Subject: Waterford 3 SES  
Docket No. 50-382  
License No. NPF-38  
Technical Specification Change Request NPF-38-218 Revision 1  
Extend Pressure Temperature Curve to 16 EFPY

**Technical Specification Change Request NPF-38-218 Revision 1  
Extend Pressure Temperature Curve to 16 EPFY**

**NPF-38-218 REVISION 1**

FIGURE 3.4-2

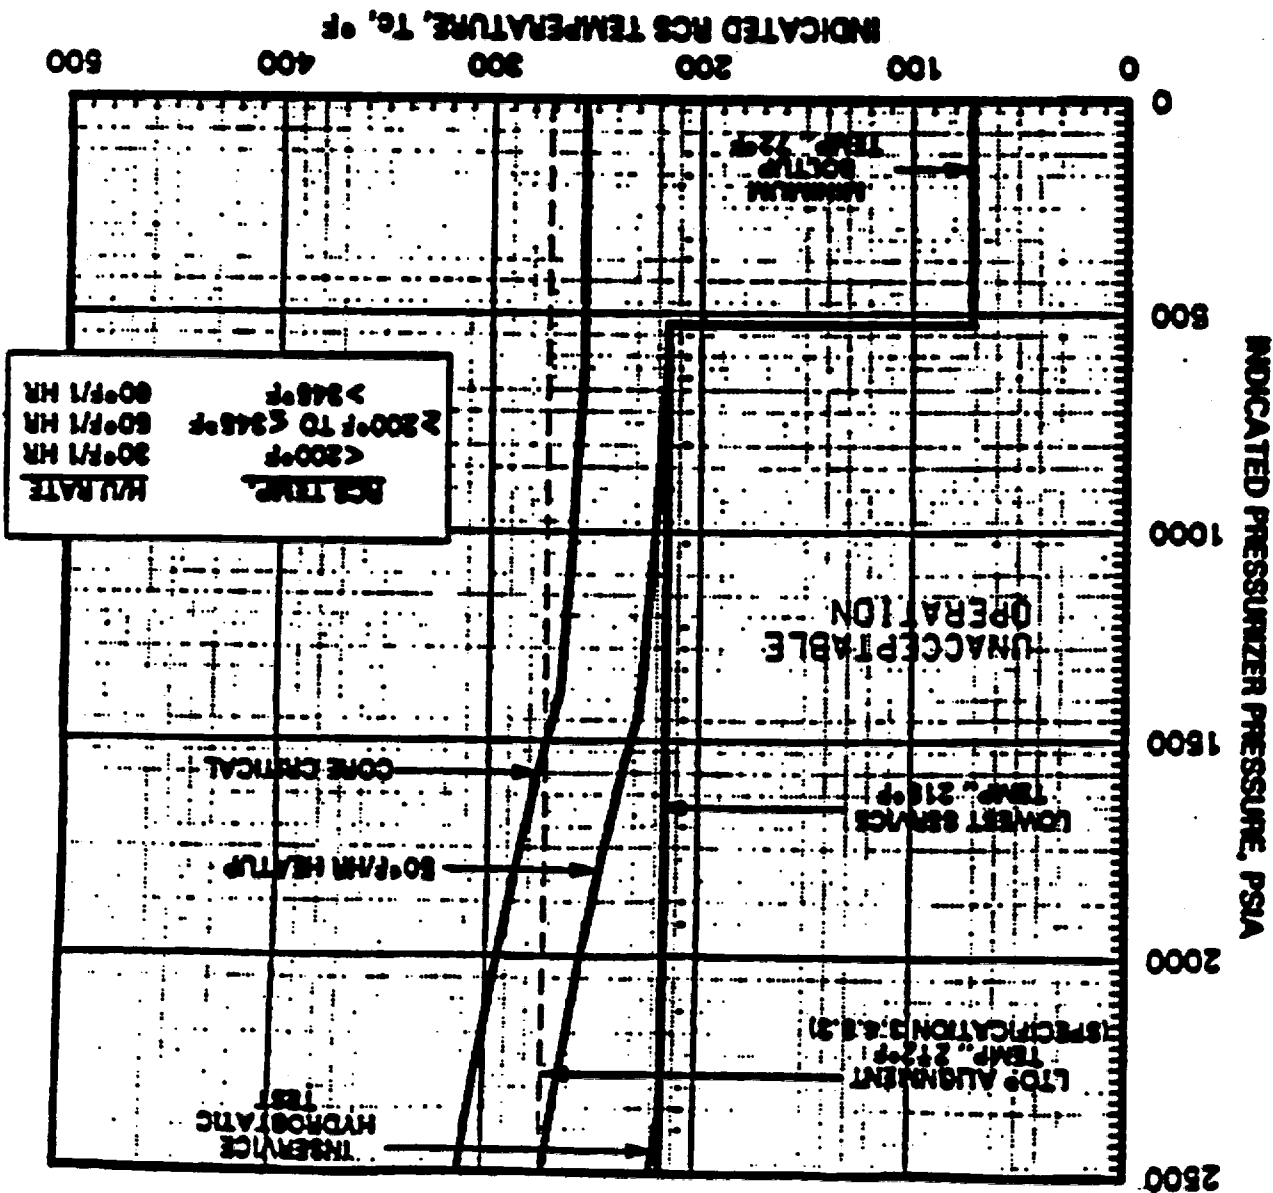
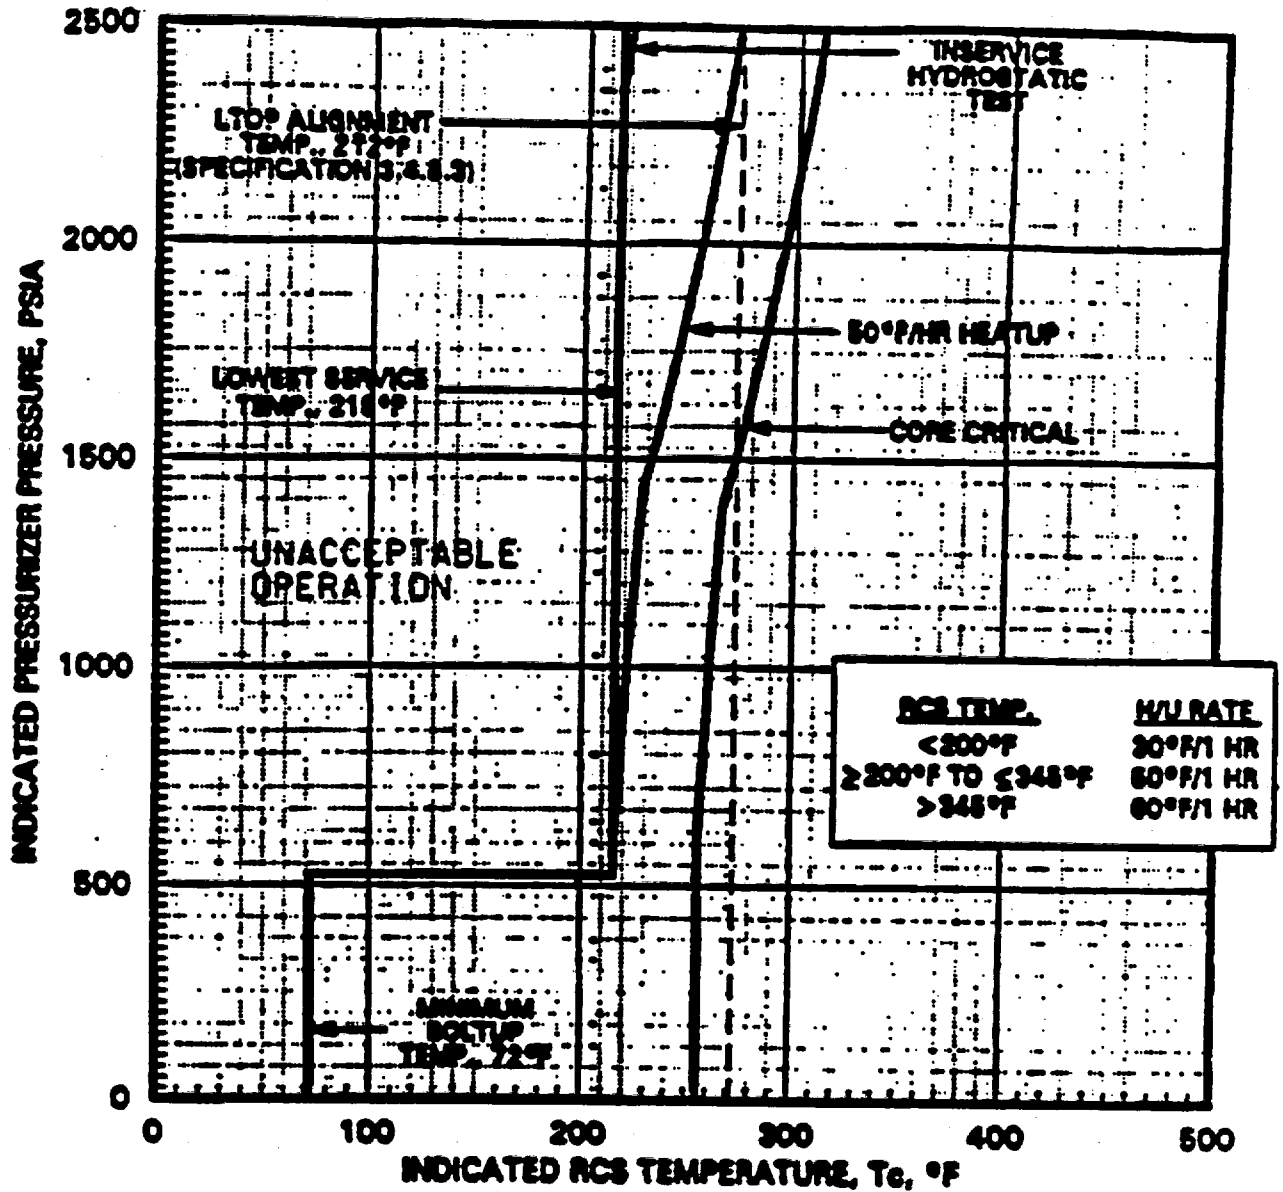
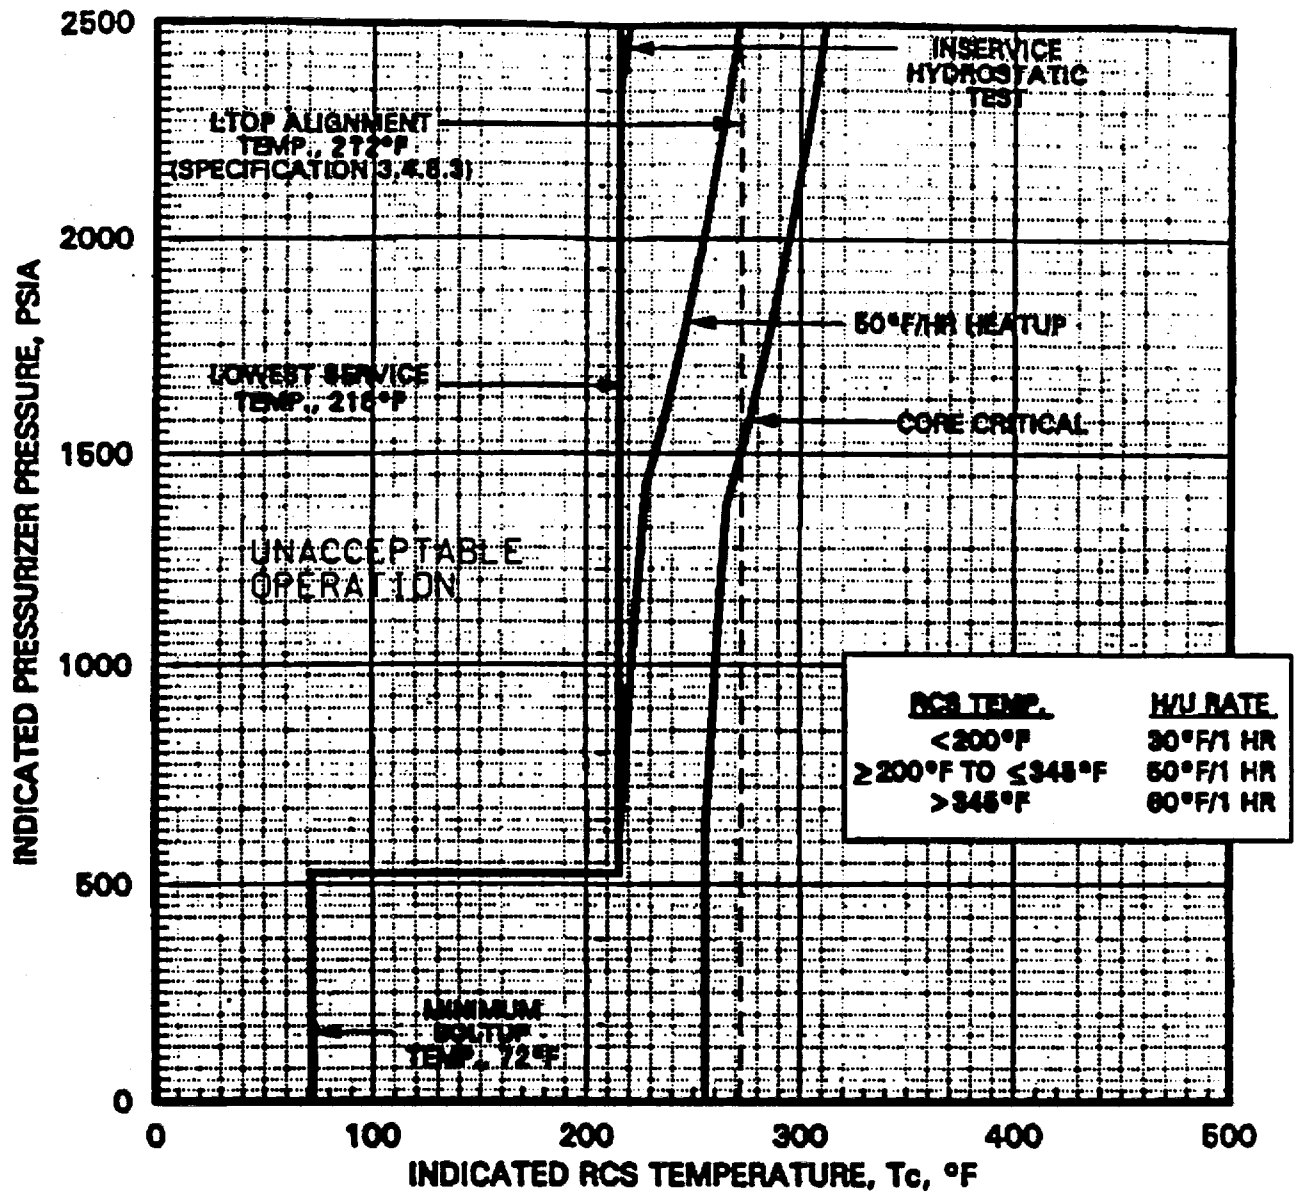
0-15 EFY

16

0-16 EFY

FIGURE 3.4-3

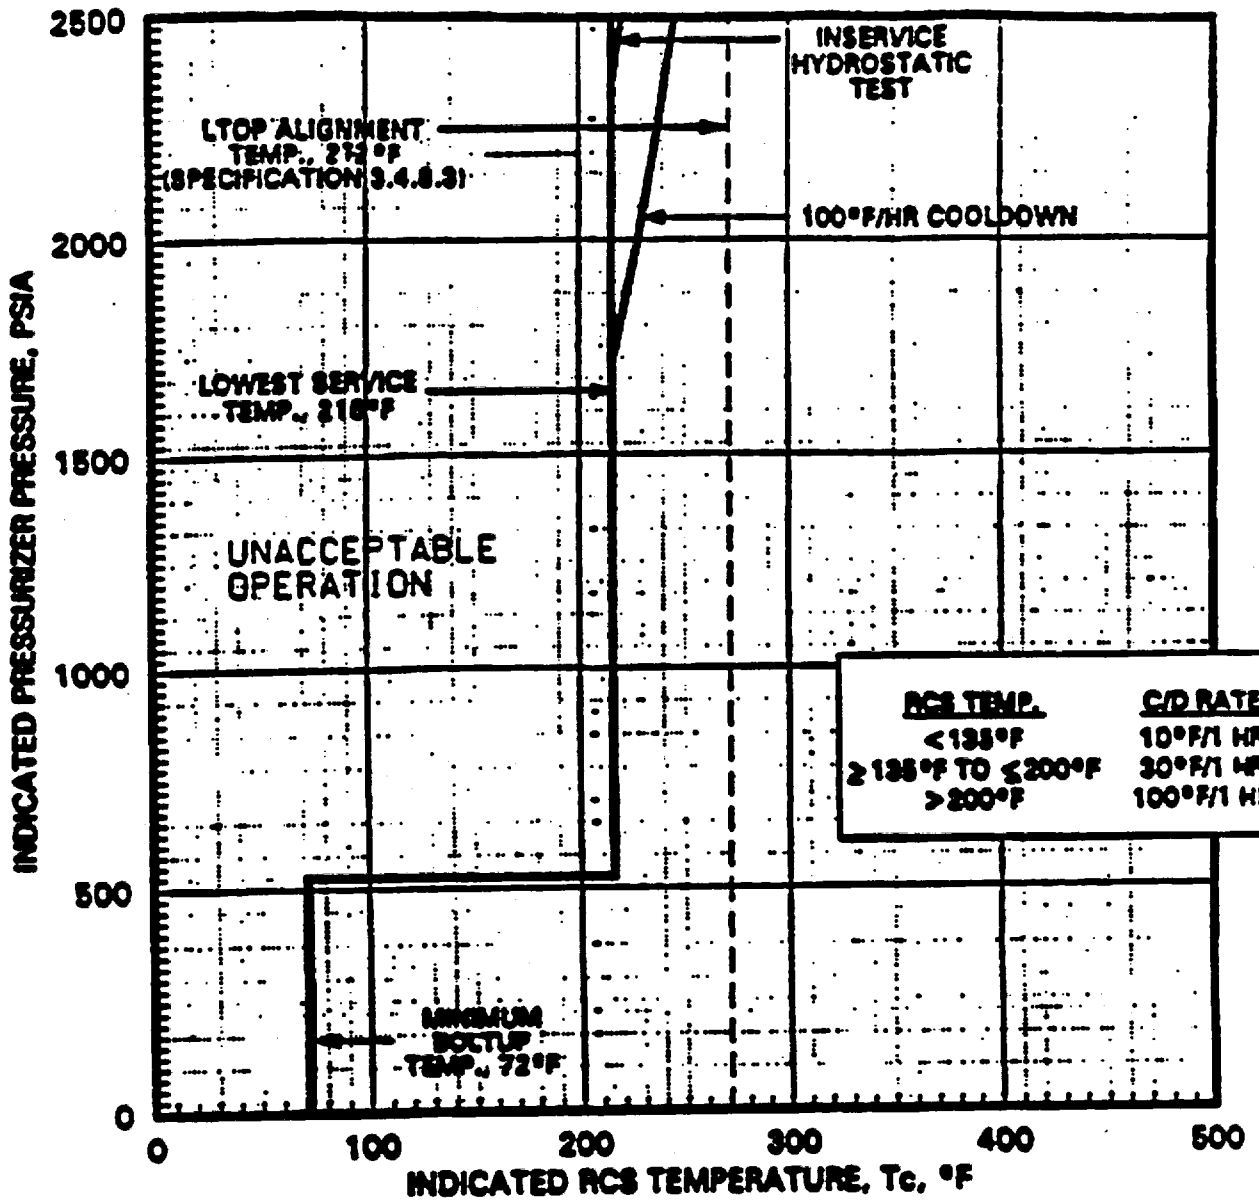
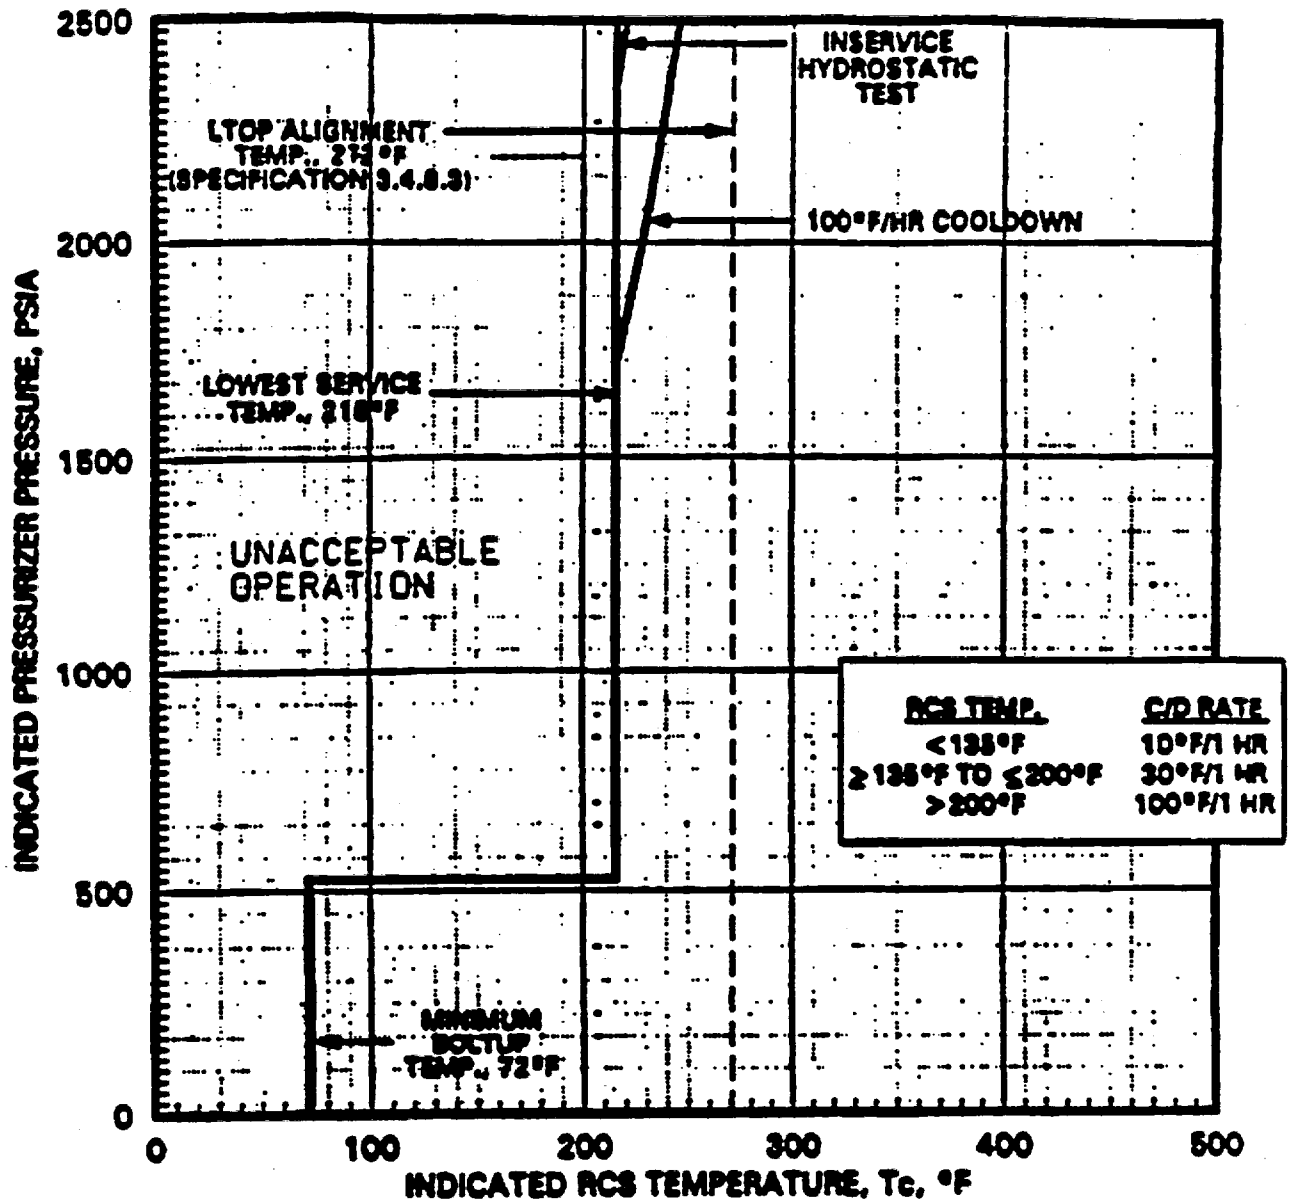
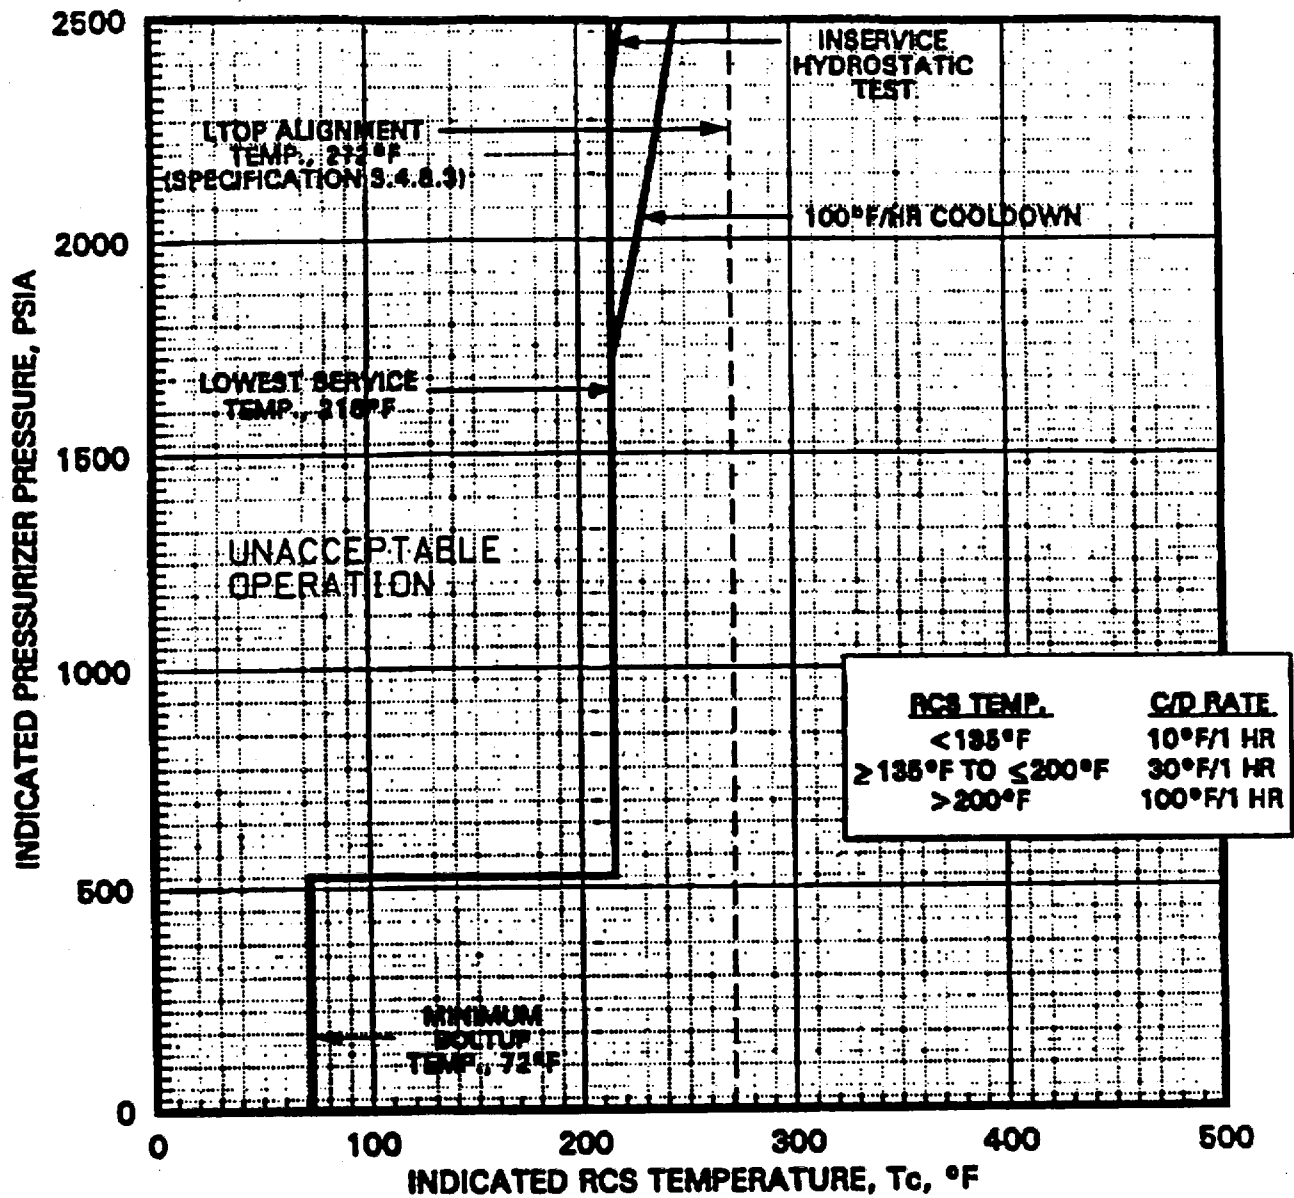
0-15 EFY

16

0-16 EFPY
